PRODUCT CHANGE NOTICE

Change Notice No. 215

Component Product Title: PILOT XL Task and XL Stool Seat Board/Seat Foam

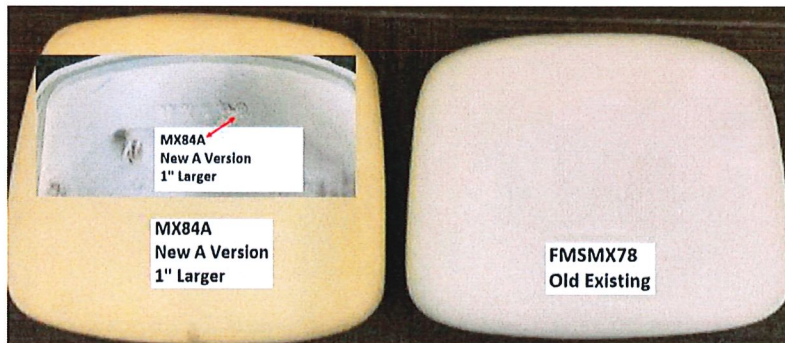
Description of Change: Increased Seat Depth. 1" added to the front edge of seat board and seat foam.

Old Board/Foam/Plate # SEAMX84 New Board/Foam/Plate #SEAMX84A

New Foam #MX84A (Part Number Stamped In Foam) Old Foam # FMSMX78

Reason: 1" seat depth (increase) to match the majority of task chair models seat depth dimension. Improve leg support for chair occupants.

XL Current Seat Depth 17-19.5"

XL New Seat Depth 18-20.5"
